**Paycor Stadium Southeast & Southwest VT Escalator Towers
Bid Package 2: Steel, Demo & Concrete
ITB#033-26
Addendum 3**

May 6, 2026

Crane

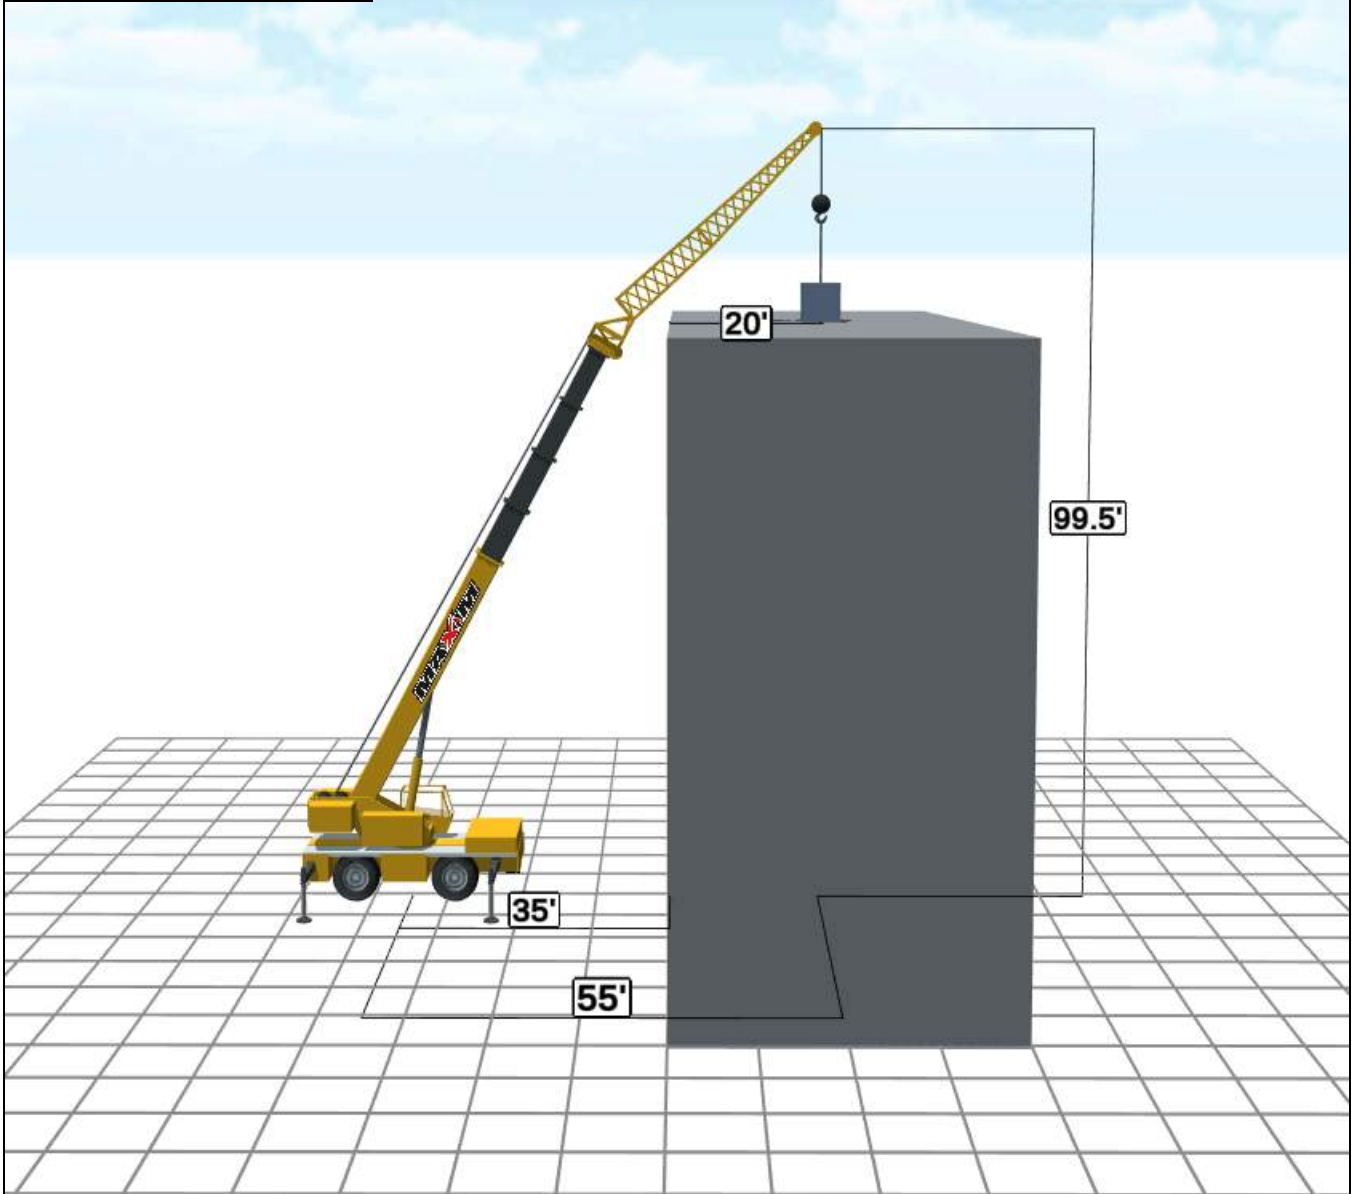
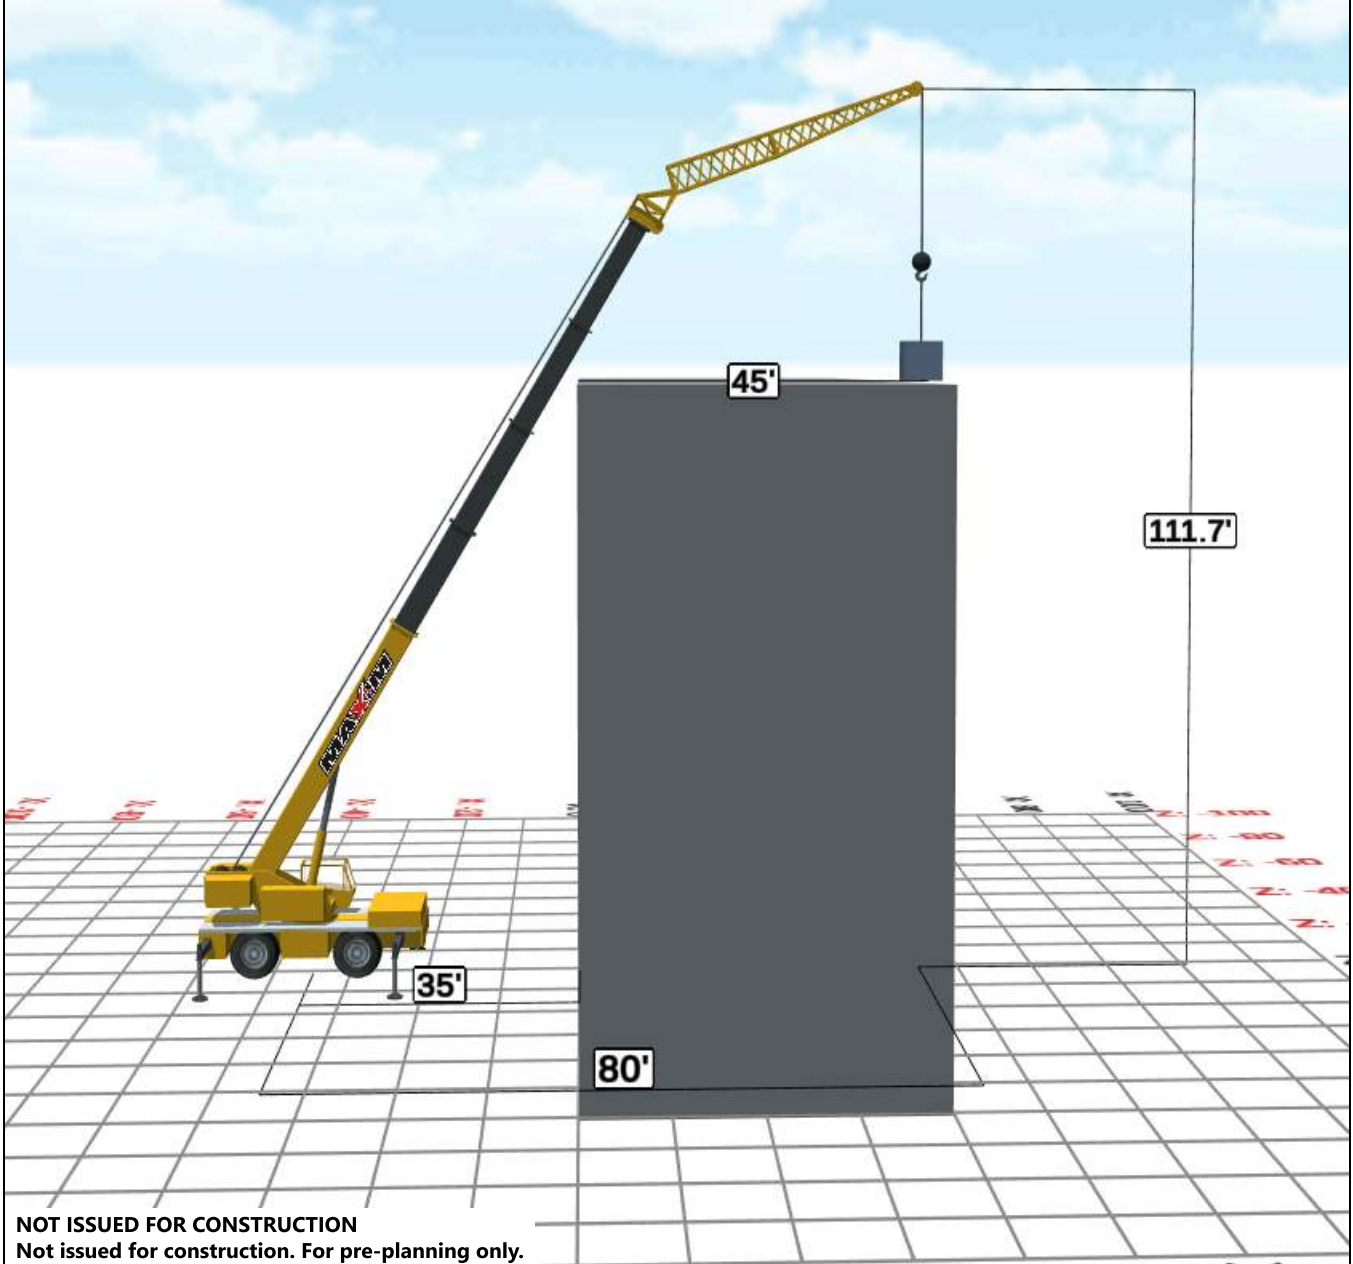
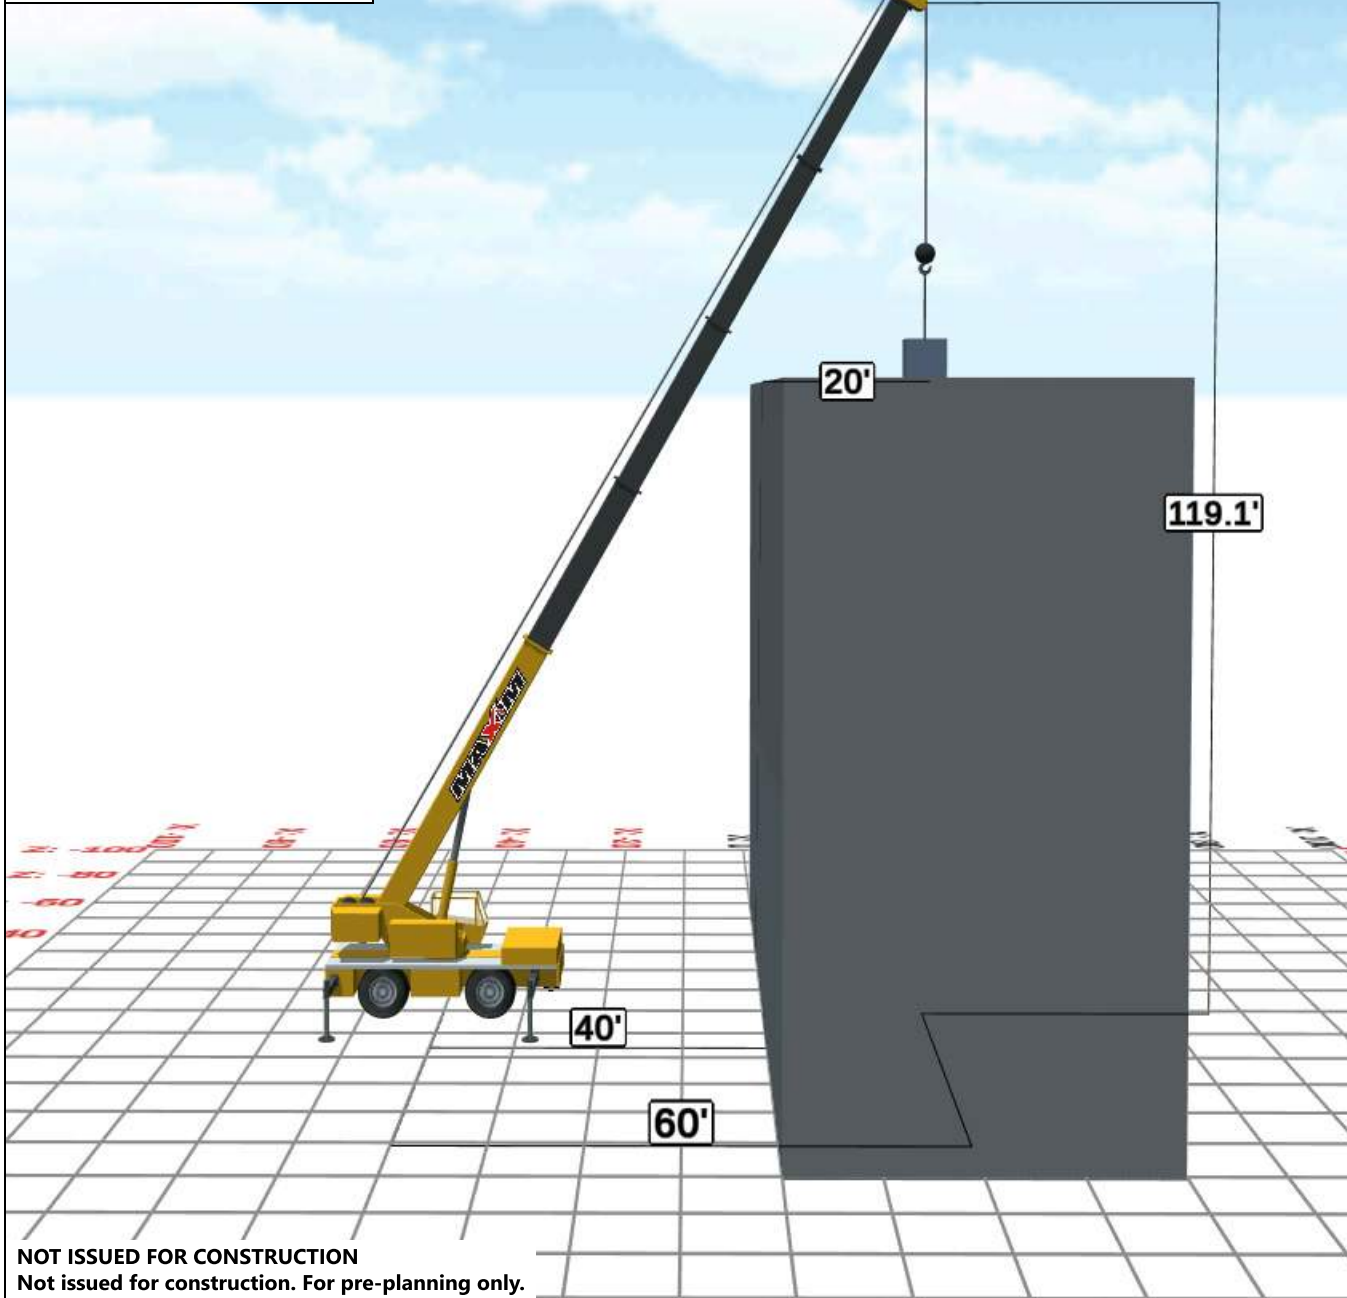
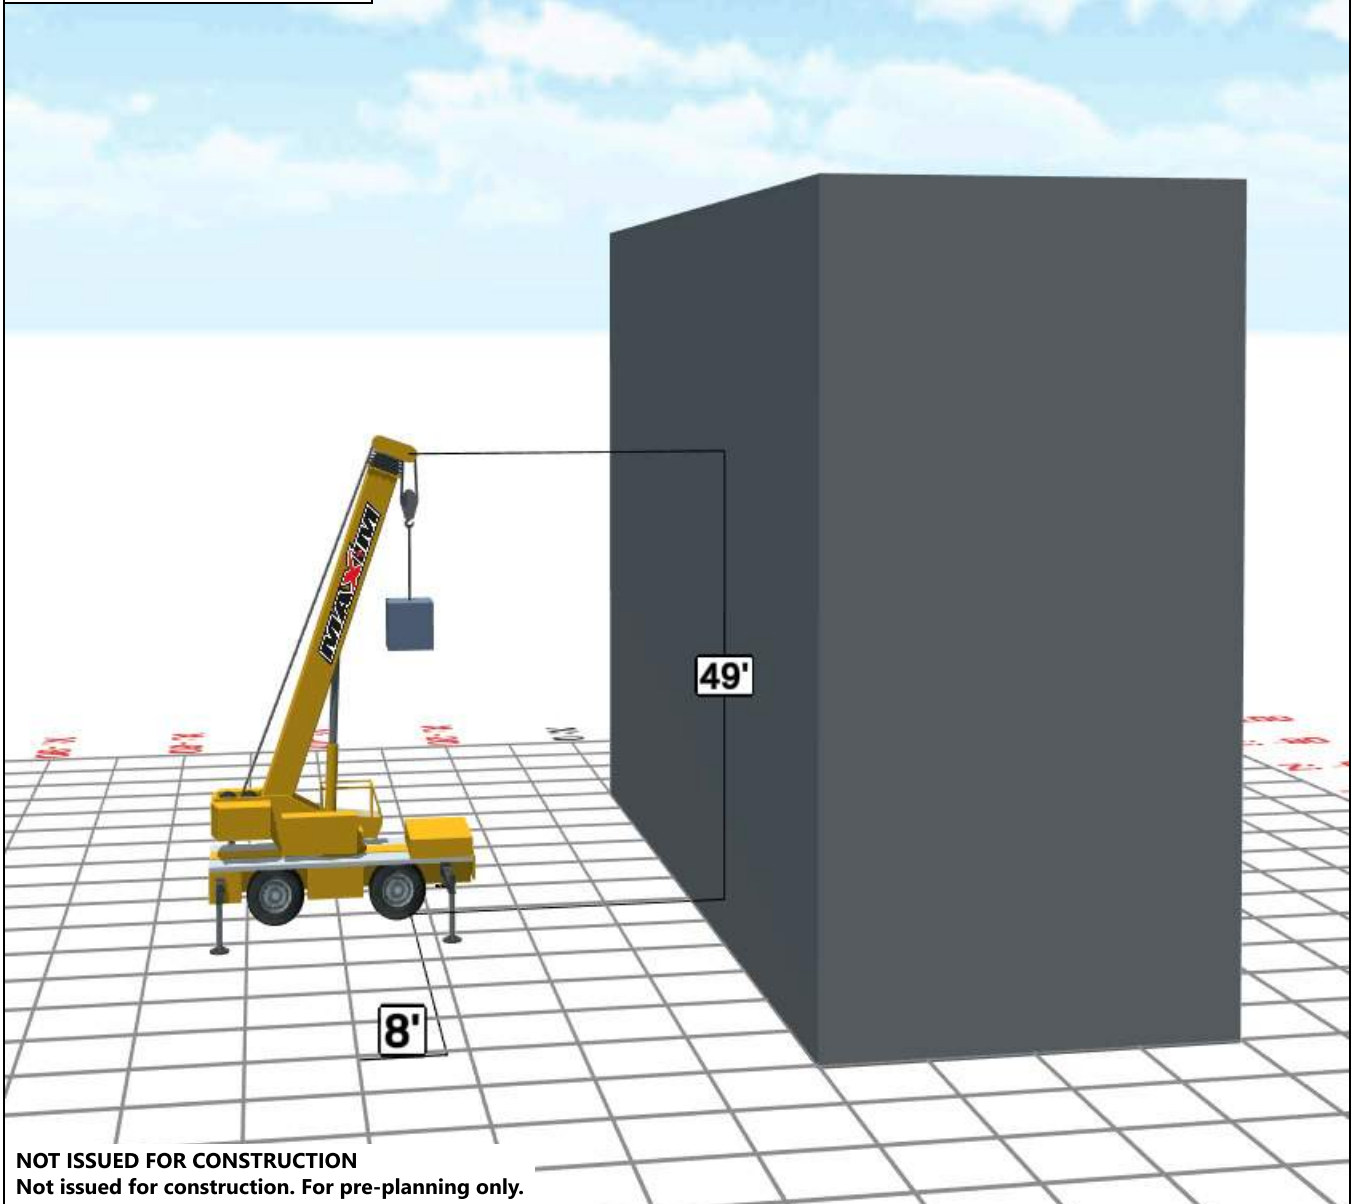
6. Can the bid date be extended to allow more time for contractors to prepare pricing?
Answer: Yes. Bid opening extended to Friday May 15, 2026
7. What is the anticipated point load for the outriggers on the crane on the East side to be assumed for the shoring purposes?

22. The crane size for the Southeast scope is noted in the scope as a 100 ton crane. The information provided is for a 250 ton crane. Please clarify which crane is to be included.

Answer: See attached crane specifications
8. Will the MEP’s under the deck in the Eastside shored area be moved by others prior to shoring installation?

Answer: See attachment for East Tower Crane specifications.
